Office Action Summary	Application No.		Applicant(s)	
	10/730,759		MELLOR ET AL.	
	Examiner		Art Unit	
	Erik D. Preston		2834

DETAILED ACTION

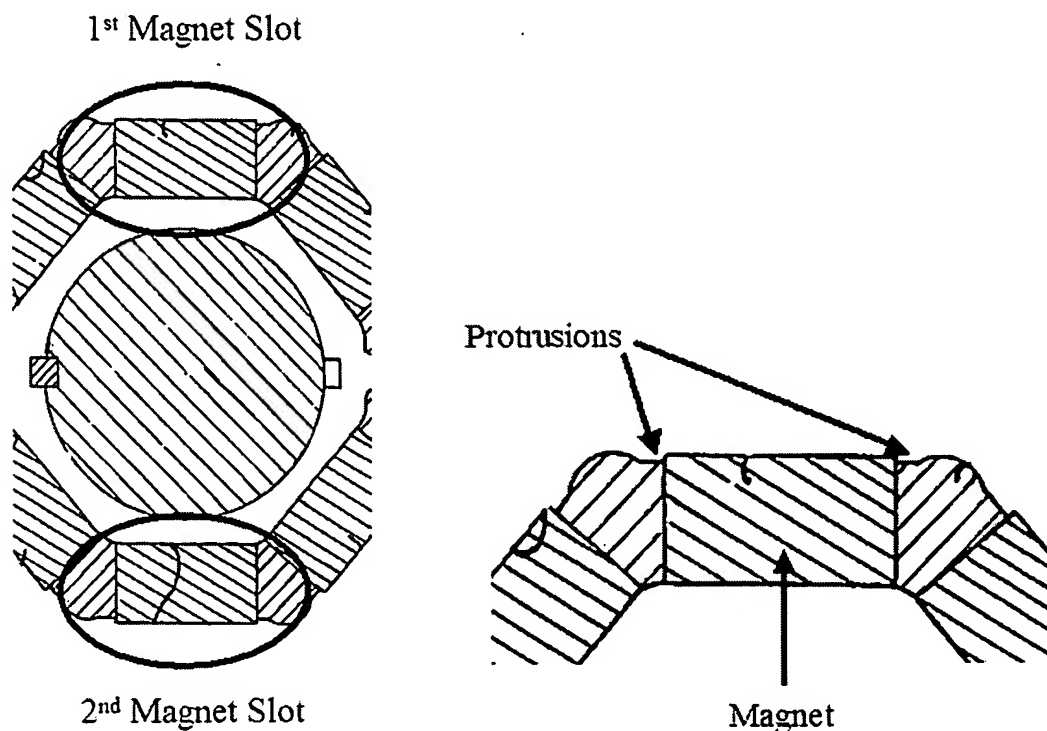
With respect to claim 15, Steen teaches an electric machine comprising: A stator (as seen in Fig. 3, #14); and a rotor (Fig. 9, #93) mounted for rotation with respect to the stator, a plurality of magnetic slots (Fig. 9, #101 & 102 & Fig. Below) separated from each other by at least a portion of a lamination layer each slot comprising opposed end portions (Fig. 9, #117) and a central portion disposed between the end portions, the central portion of each of the magnet slots shaped to complementarily receive a magnet, the opposed end portions separated from the central portion by portions of the rotor that protrude at least partially into the slot (as seen in Fig. below) wherein the end portions of the magnet slots are substantially bulbous-shaped (as seen in Fig. 9, the end portions are bulbous); a number of magnets (Fig. 9, #103) complementarily received in the central portions of the magnet slots of the rotor; and a load absorbing material filling

With respect to claim 26, Steen teaches a rotor assembly of an electric machine comprising: a lamination layer configured to be axially stacked in a series of lamination layers (as seen in Fig. 2) to form a rotor core of an electric machine; a plurality of slots separated from each other by at least a portion of the lamination layer (as seen in the

Fig. above), each slot comprising opposed end portions (Fig. 9, #117) and an elongate portion disposed between the end portions, and at least one of the end portions is expanded bulbous-shaped (both end portions are bulbous shaped); a portion of the lamination layer (as seen in the Fig. above) protruding at least partially into the internal slot between the elongate portion and the at least one expanded bulbous end portion; a permanent magnet (Fig. 9, #103) disposed within each internal slot and substantially laterally restrained in the slot by the portion of the lamination layer; and a load absorbing material received in the end portions of the internal slots between a portion of a wall forming a the end portion and the respective permanent magnet disposed in the internal slot.
